SAFETY EVALUATION - DAVIS-BESSE
ELECTRICAL INDEPENDENCE BETWEEN REDUNDANT SAFETY
FEATURES ACTUATION SYSTEM INSTRUMENT AND LOGIC CHANNELS

EVALUATION

FIGURE 1

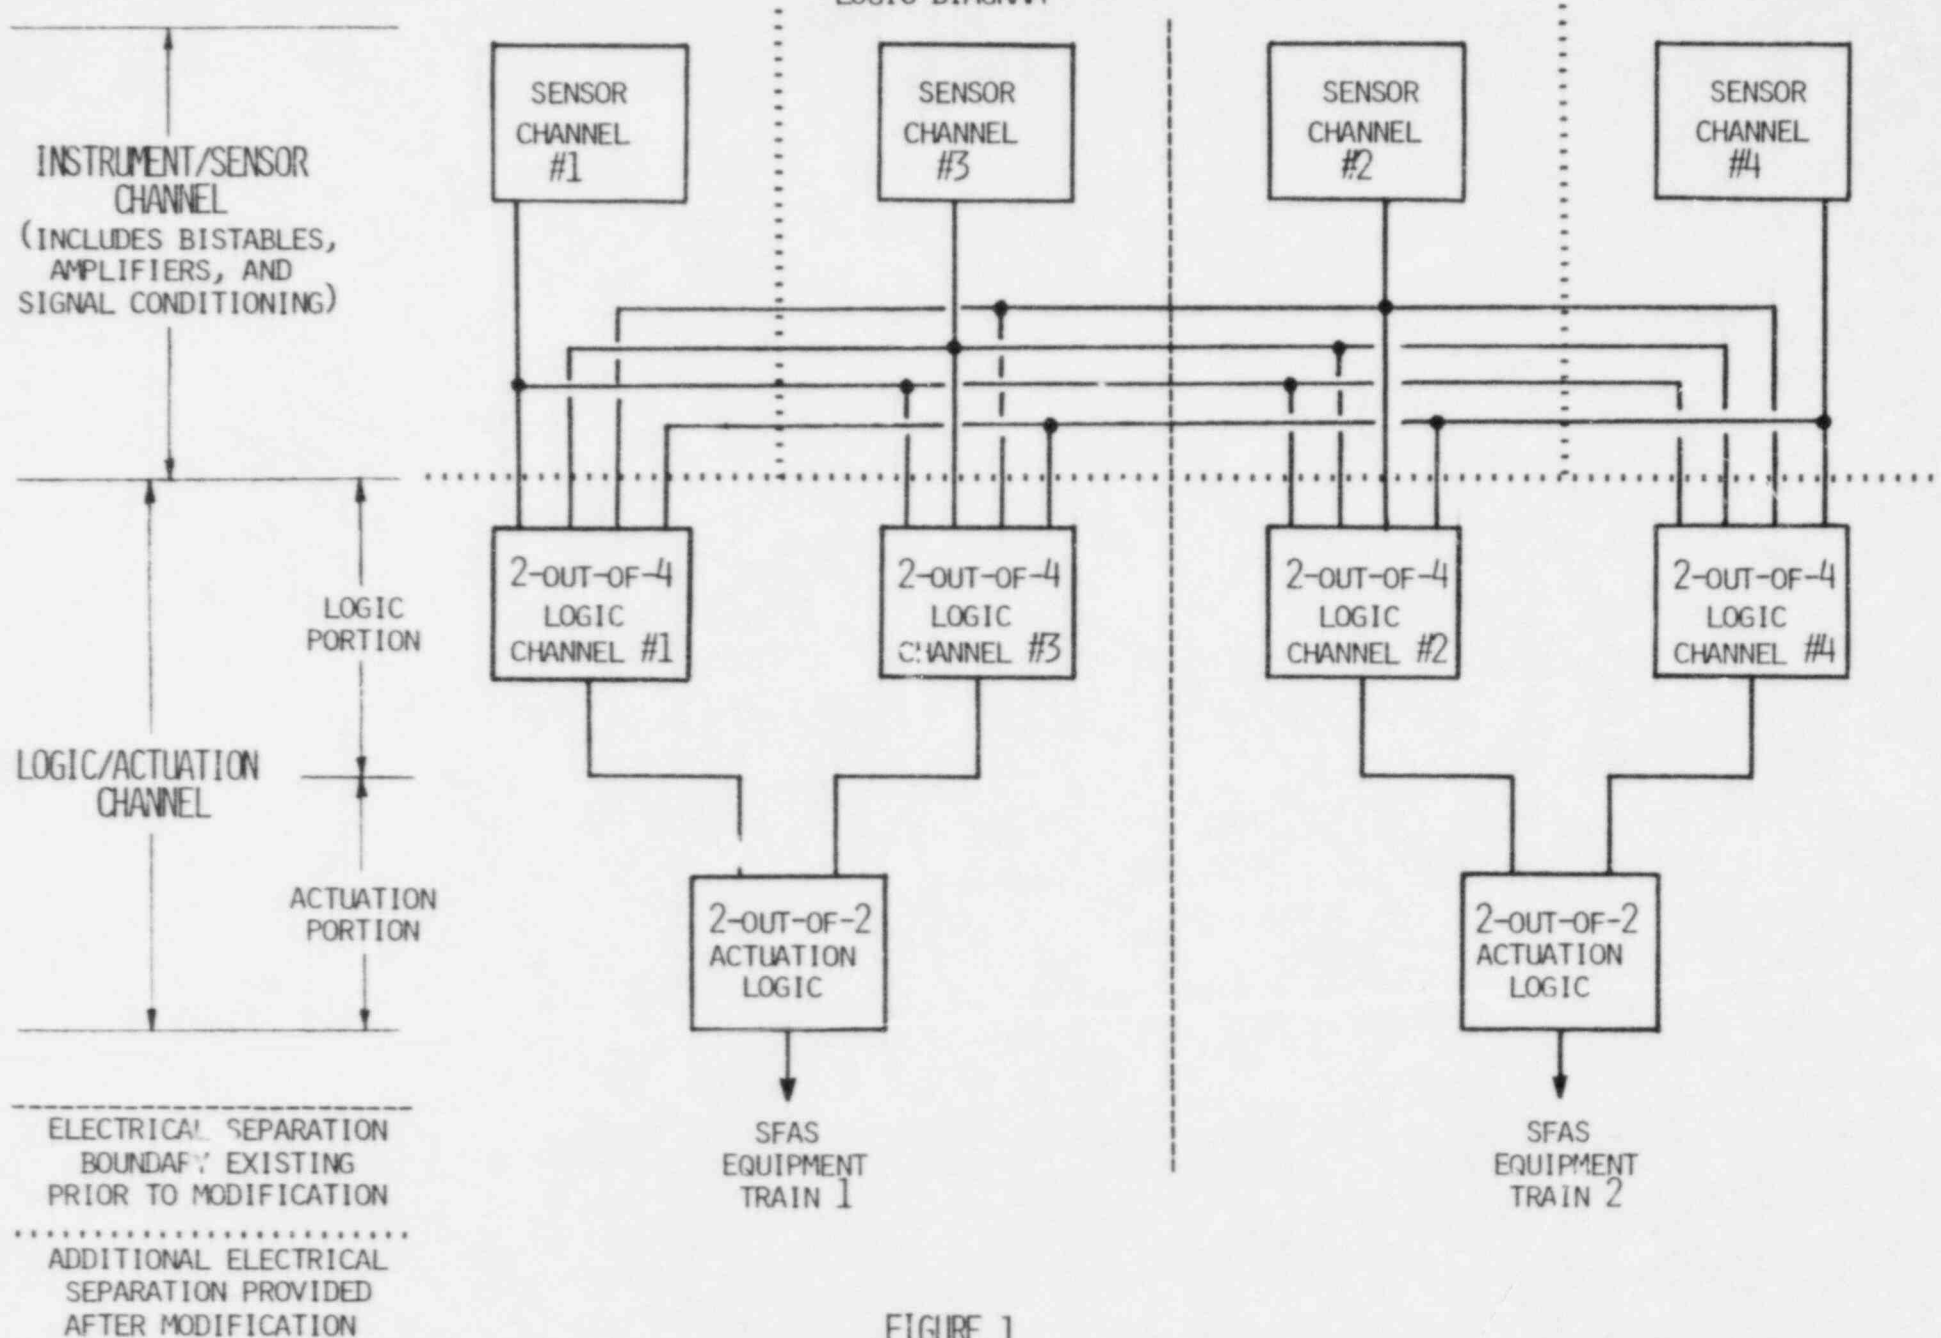
Two figures are provided at the end of this report to aid in the understanding of the material in this section. Figure 1 shows the Davis-Besse SFAS logic configuration and the boundary between instrument/sensor channels and logic/actuation channels. Figure 2 shows the SFAS power supply configuration before and after the modifications. Both of these figures reflect the general Davis-Besse SFAS design, but have been greatly simplified and should not be used to infer design details.

It should be noted that following the SFAS modifications, the logic commons for SFAS logic/actuation channels 1 and 3 will remain electrically connected as will the logic commons for channels 2 and 4. SFAS logic channels 1 and 3 are combined to actuate SFAS equipment in train 1 (powered from division 1). Both channels 1 and 3 must trip to cause actuation. SFAS logic channels 2 and 4 operate in a similar fashion to actuate equipment in train 2 (powered from division 2). Because the logic/actuation channels associated with a given train of SFAS equipment are not electrically independent, an electrical fault condition associated with a shared logic common could be postulated to disable both logic/actuation channels and therefore, to disable the safety functions of one train of SFAS equipment. However, this situation is not considered more limiting than other failure modes (e.g., loss of divisional power), where SFAS equipment in the redundant train is relied on to accomplish required safety functions. Furthermore, since the two logic/actuation channels associated with

a given SFAS train are arranged in a 2-out-of-2 (logical "AND") configuration (i.e., both channels must trip to cause equipment actuation), a single failure of either logic/actuation channel will preclude the SFAS safety functions of a single train. However, four electrically independent logic/actuation channels are not required to comply with NRC regulations. A four channel design in which dependent logic channels are combined to form two electrically independent actuation channels, such as the Davis-Besse design, is acceptable if properly implemented. Therefore, the electrical connections between redundant logic commons are considered acceptable provided that adequate isolation exists between the sensor and logic portions of each SFAS channel (such that faults within the logic portion can not affect instrument/sensor channel performance), and that faults within the logic portion of the SFAS are detectable.

There are two types of interfaces which occur between the instrument/sensor portions and the logic/actuation portions of the Davis-Besse SFAS. The first and most frequently used interface occurs at the bistable module outputs. Each bistable for each SFAS monitored parameter (containment radiation, containment pressure, reactor coolant pressure, and borated water storage tank level) provides four isolated outputs, one output to each SFAS logic channel. Thus, even the output signal to the associated logic channel is isolated. Isolation is provided by opto-electronic devices housed in the bistable modules. The second interface occurs at the reactor coolant pressure bistable modules used to generate block permissives that allow manual bypass of the reactor coolant low pressure trip functions. Here, relay coil-to-contact isolation is used between the logic channel (+24 Vdc relay side) and the instrument channel (+15 Vdc contact side). The staff concludes that the isolation provided between the sensors channels and logic channels is acceptable to maintain sensor channel independence. All other instrument channel circuits (e.g., indicators, annunciator outputs, computer outputs, etc.) are isolated using relay coil-to-contact isolation or current-to-current converters. The licensee has stated that the physical separation between redundant SFAS sensor and actuation channels, reviewed and approved during plant licensing, has not been compromised as a result of the SFAS modifications discussed above.

FIGURE 2

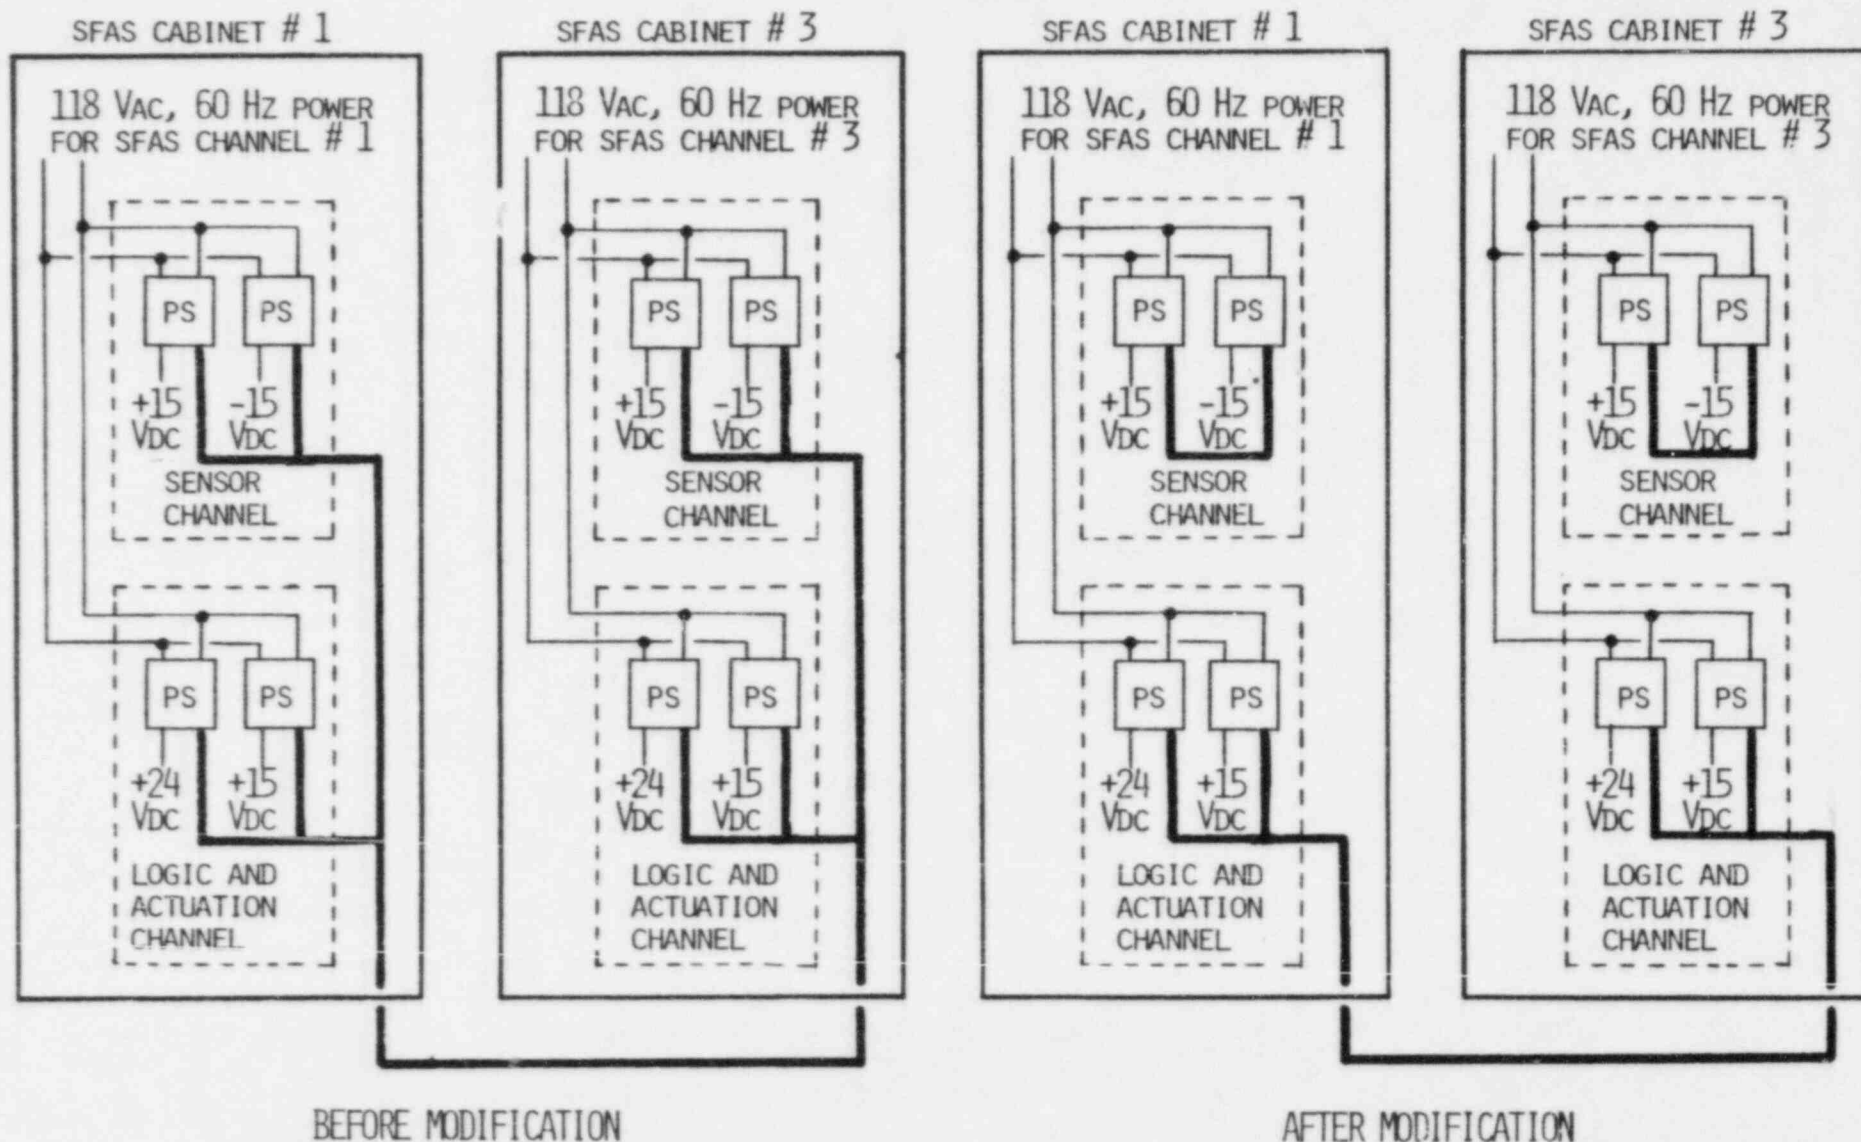
The Davis-Besse SFAS design uses ± 15 Vdc and $+24$ Vdc power supplies. The -15 Vdc supplies provide power to sensor/instrument channel components only. The $+24$ Vdc supplies provide power to logic/actuation channel components only. The $+15$ Vdc supplies provide power to both the instrument and logic portions of the SFAS. The SFAS dc power supply design uses a floating ground system, i.e., the power supply returns (commons) are isolated from the SFAS cabinet structure which is connected to the instrument-station ground system. The floating returns for SFAS instrument channel #1, logic channel #1, instrument channel #3, and logic channel #3 are electrically connected (hardwired). Similar connections exist between SFAS channels 2 and 4. These connections between redundant SFAS channels led to the channel independence and single failure concerns identified by the staff. The floating return configuration was selected by design to reduce the number of contacts (and thus the amount of field run wiring) from SFAS relays and control switches needed to actuate SFAS equipment, and to reduce the potential for degradation of SFAS performance given a fault voltage existing between the SFAS dc common and the SFAS cabinet structure.

To provide electrical independence between redundant SFAS instrument channels, four new $+15$ Vdc supplies will be used to provide power to instrument channel components. New power supplies will be added to SFAS cabinets 2 and 4, and existing $+15$ Vdc supplies which are currently spares will be used in SFAS cabinets 1 and 3 (these supplies were originally provided for automatic test circuitry which is no longer used). These supplies will provide power to instrument channel components only (amplifiers, current isolation converters, bistable modules, etc., and associated test and calibration circuits). The existing SFAS $+15$ Vdc supplies that were previously used for both instrument and logic channel components will now be used to provide power to SFAS logic/actuation channel components only. The four instrument channel $+15$ Vdc supplies will be electrically independent from each other, and each supply will be electrically separated from its corresponding $+15$ Vdc logic channel power supply. Thus, each SFAS instrument channel will have its own dedicated $+15$ Vdc and -15 Vdc power supplies. These supplies will share the same floating ground (designated as the "sensor common"). The sensor commons of redundant SFAS

instrument channels are not connected, thus maintaining channel independence. Each SFAS logic/actuation channel will have its own dedicated +15 Vdc and +24 Vdc power supplies which share a separate floating ground (designated as the "logic common"). The sensor common and logic common within each SFAS cabinet are not connected, thus maintaining electrical separation between the sensor and logic portions of the SFAS. All connections which previously tied the sensor and logic commons together and redundant instrument channel supply commons together have been eliminated.

The above modifications can be accomplished by circuit modifications within the four SFAS. The electrical separation of redundant sensor commons will assure that the effects of SFAS power supply failures similar to that which occurred prior to the inadvertent actuation on December 5, 1980 will be limited to a single SFAS instrument channel (i.e., multiple/redundant channels will not be affected). In addition, since the floating power supply return configuration has been retained, the above modifications will not make the SFAS more vulnerable to spurious trips or equipment damage from electrical faults, and connections between the SFAS and the instrument-station ground system have been avoided.
